STATE OF NEW YORK  
OFFICE OF THE ATTORNEY GENERAL

August 3, 2010

Re: *Supplemental Comments Concerning Indian Point Draft SEIS*

Hillshade from USGS 10 meter digital elevation model  
(Prepared with ESRI GIS Software)

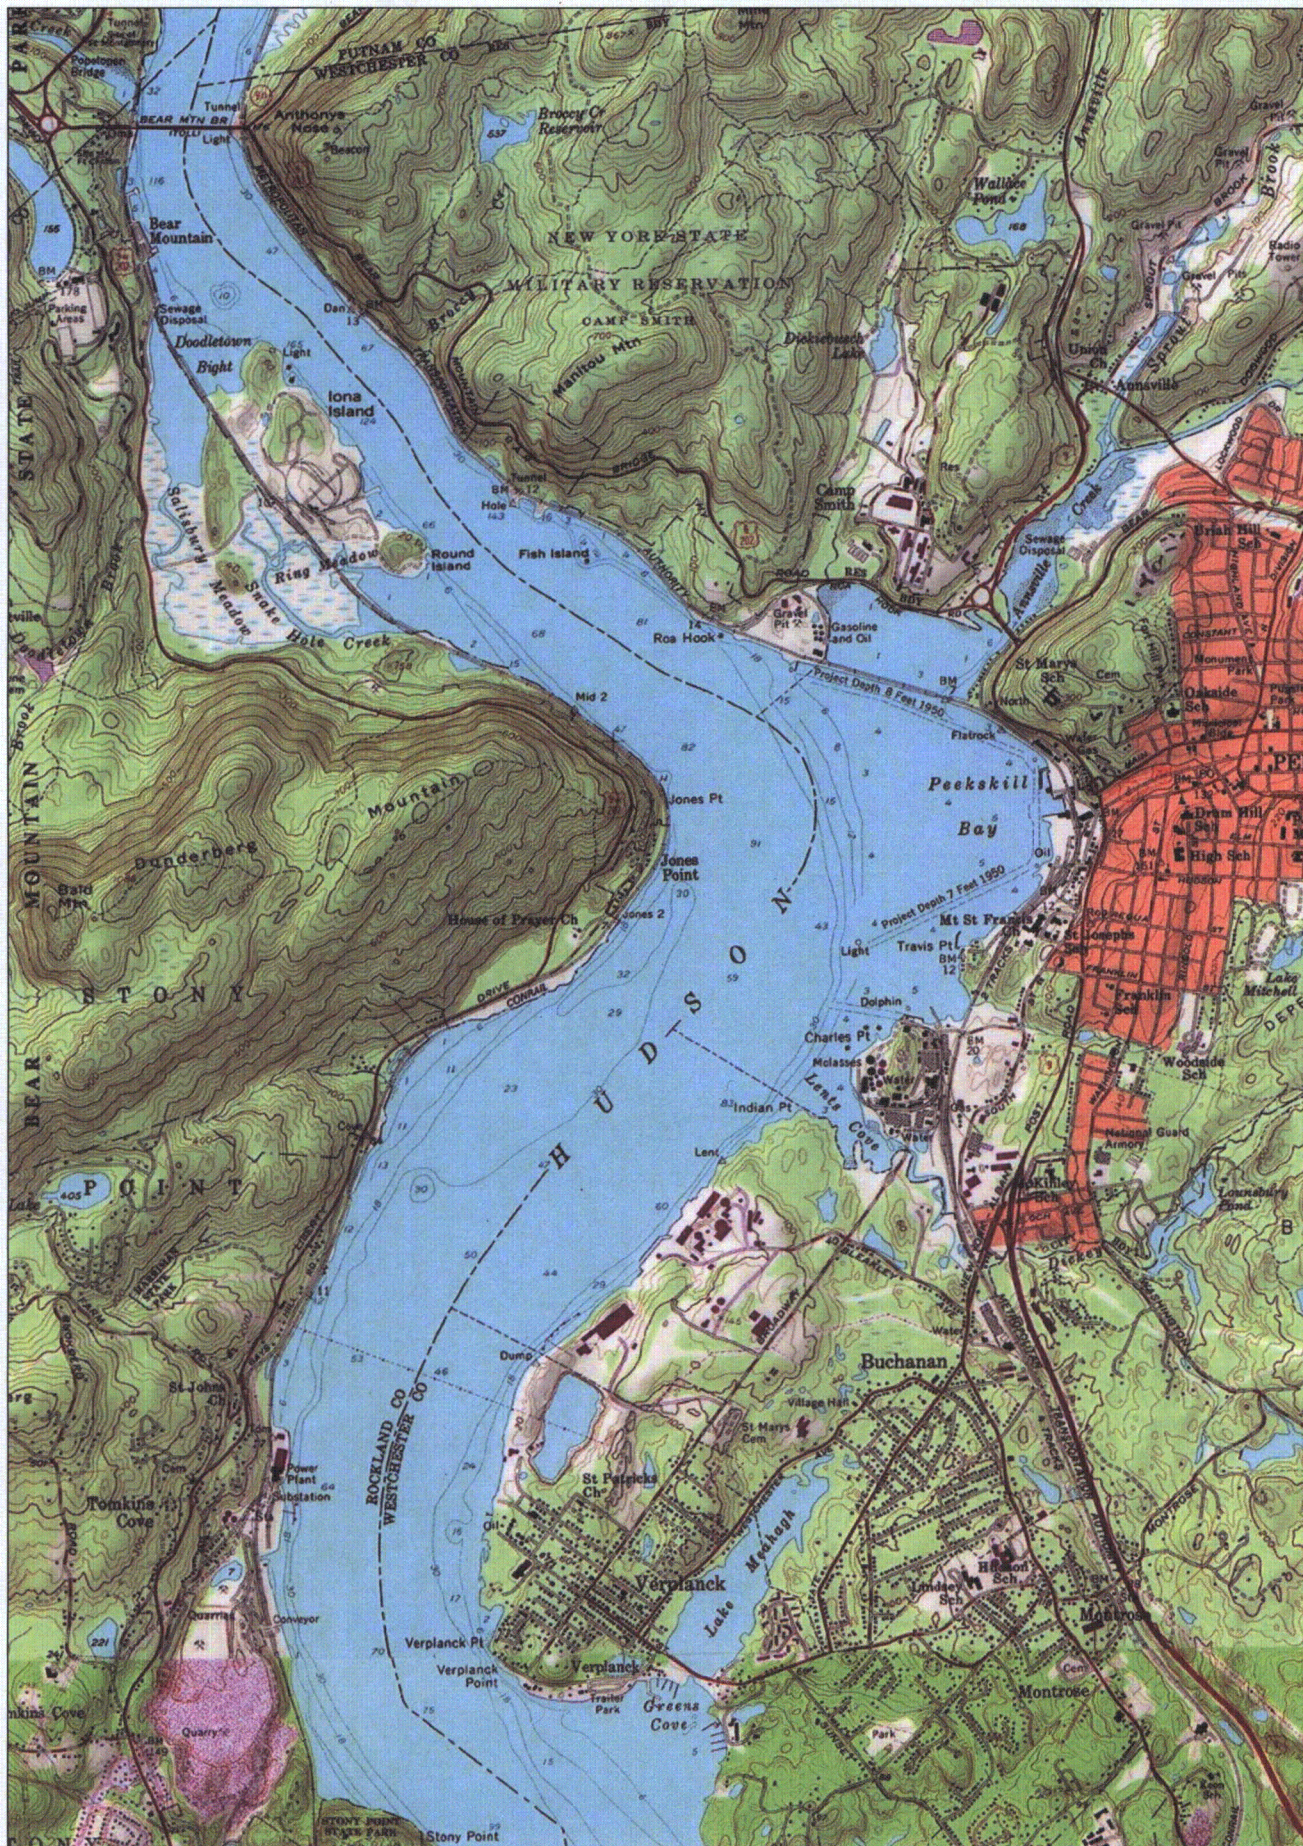
As the State of New York has previously informed NRC, Figure 2-9, which appears on page 2-25 of the Draft Supplemental Environmental Input Statement (DSEIS), is incomplete and, thus, presents an inaccurate depiction of the topography, river valley, and river course and turns near the Indian Point facilities. To adequately assess the license application and its safety and environmental impacts, the Staff, Atomic Safety and Licensing Board, Commissioners, and the public require a complete and accurate depiction of such features.

Accompanying this letter are three maps that contain an accurate depiction of the topographic and river features surrounding the facilities. Please replace the inaccurate Figure 2-9 with the accompanying maps in any subsequent environmental impact statement.

- (1) hillshade map, using USGS 10m digital elevation model (scale: 1 mile =  $1\frac{3}{16}$  inch)
- (2) hillshade map, using USGS 10m digital elevation model (scale: 3 miles = 1 inch)
- (3) topographic map, using National Geographic Society and ESRI data
